SUBMISSION FOR THE ST LEONARDS SOUTH DRAFT MASTER PLAN

- 1.1 Milestone (Aust) Pty Limited (Milestone) has been engaged by the Greenwich St Leonards Action Group and write with regard to the St Leonards South Draft Master Plan (Draft Master Plan) prepared by Annand Associates Urban Design for Lane Cove Municipal Council (Council).
- 1.2 Based upon a review of the Draft Master Plan documentation made available on Council's website, a site inspection of the Master Plan area and the surrounding built form and its context, we strongly object to the Draft Master Plan on the following grounds:
 - Vehicle access and congestion impacts;
 - Parking impacts;
 - Overshadowing impacts;
 - Privacy impacts;
 - Unreasonable height and density;
 - Excessive bulk/scale streetscape impact;
 - Lack of green open space;
 - Loss of character; and
 - Lack of consideration for precinct context.

Figure 2: Current traffic bottlenecks in Draft Master Plan area
Source: SIX Maps 2015

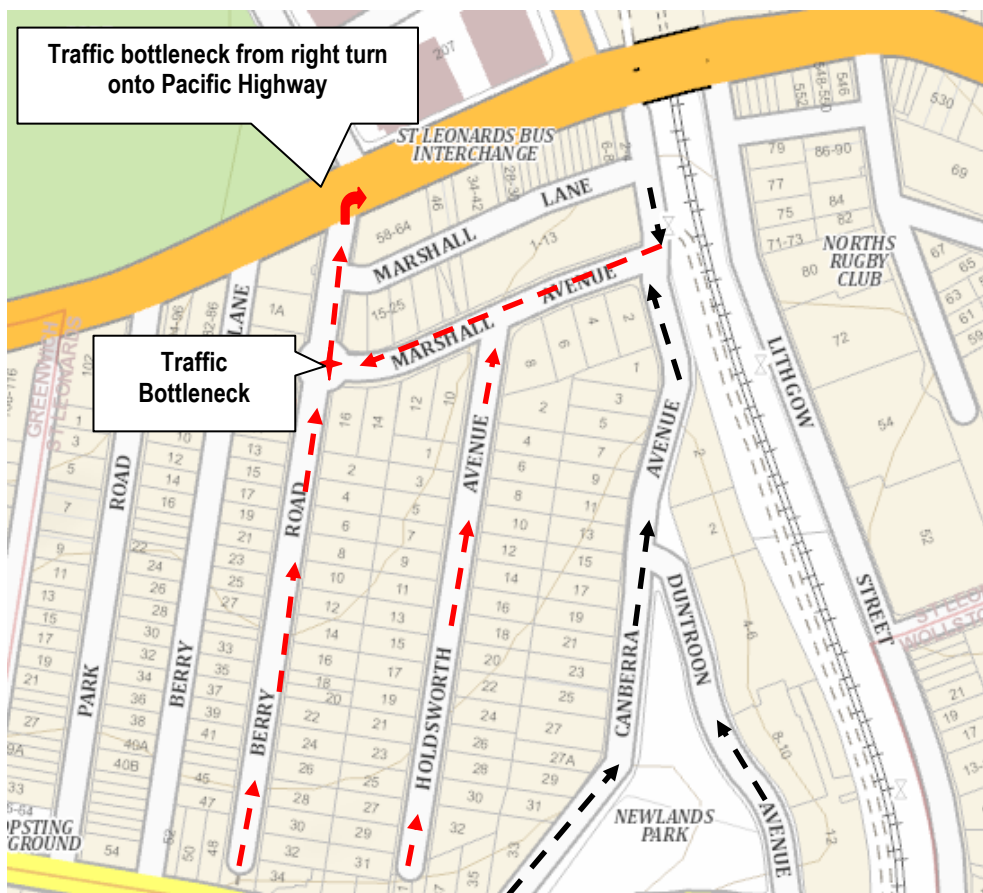
- 3.4 We express concern that the rezoning of the Marshall Avenue South Sub-precinct to high density will create a traffic bottleneck on Marshall Avenue and Berry Road as vehicles attempt to access the Pacific Highway via these streets. We highlight that Berry Road towards the Pacific Highway is a "short" (with approximately 45 metres of usable space) road and can only accommodate a few cars to queue to exit Berry Road. We also note that Berry Road is the only street that permits a right turn onto the Pacific Highway in the vicinity of the site and wider catchment of Greenwich and therefore acts as the main 'feeder' road to this arterial road (refer to **Figure 2**). Consequently, Berry Road becomes highly congested during peak hour periods and also experiences congestion during off peak periods, including on weekends.

- 3.5 We consider that Council's suggestion that traffic from a further 2,000 new dwellings (based on Proposal 1 for High Density) could be accommodated without the need for significant infrastructure renewal and within the current street network is unrealistic and will pose significant adverse traffic and congestion impacts.

Figure 3: Overshadowing impacts at 9.00am to Eastern Facades from the 'Preferred Option'
Source: Draft Master Plan (page 23 of Appendices)

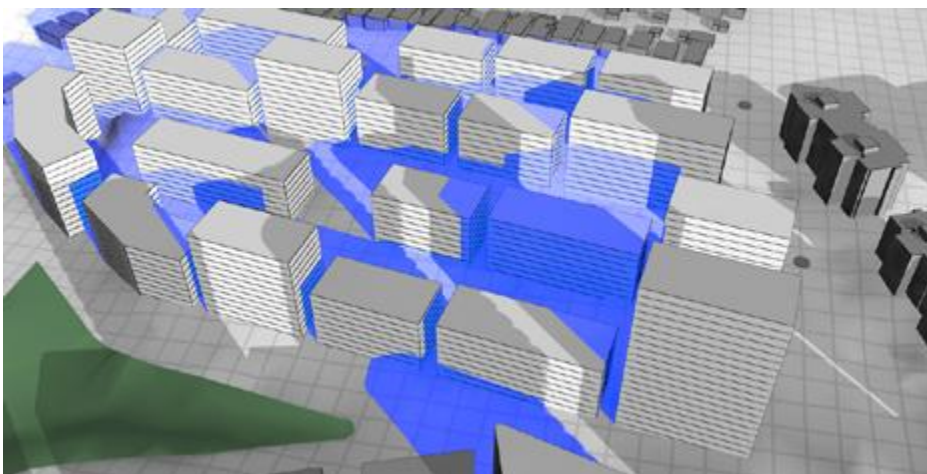
- 3.9 Many of the residents in the locality have a useable front garden which acts as the only private open space available. The proposed rezoning and any subsequent high density development will significantly overshadow a large portion of houses; particularly during the morning hours (refer to **Figure 3**). Accordingly, this overshadowing will have considerable detrimental implications for the enjoyment of the private open space available to residents.

- 3.10 The overshadowing diagrams held in the Appendices to the Draft Master Plan do not fully account for the potential overshadowing impacts especially given not all sites will be built at the same time. The houses left behind or developed later will be overshadowed considerably for an unknown period of time. Therefore, the overshadowing diagrams underestimate the full extent of the potential overshadowing impacts from high density development in the area.

- 3.11 Given the topographic conditions, south facing slopes will result in unreasonable overshadowing implications.

Figure 5: Height Progression from Pacific Highway
Source: St Leonards Strategy 2006

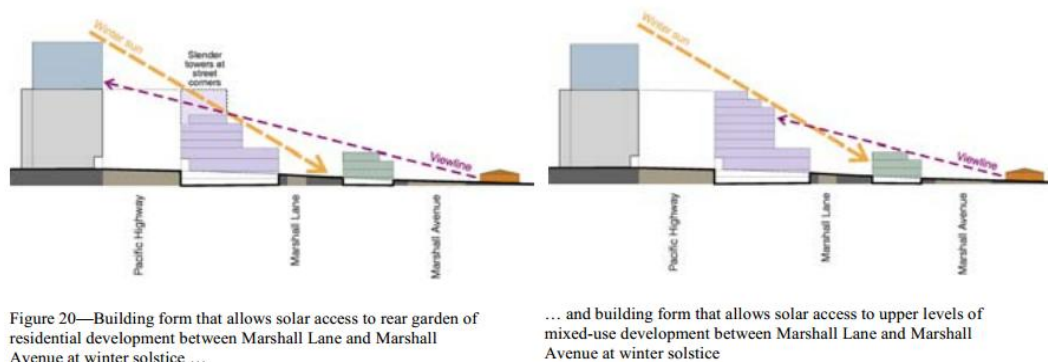
3.18 **Figure 5** below shows Figure 20 of the St Leonards Strategy 2006, which supports the recommendation to step the height down from the Pacific Highway to the south.

- Provide a 'transition area' between high density centre development and existing low density residential development The proposed heights of the high density areas in the Draft Master Plan will not result in development stepping down from Pacific Highway as intended by the St Leonards Strategy 2006 and would result in a detrimental urban design outcome.
- Provide development proposals that consider the nature of the precinct (for example the topography and character of the area).
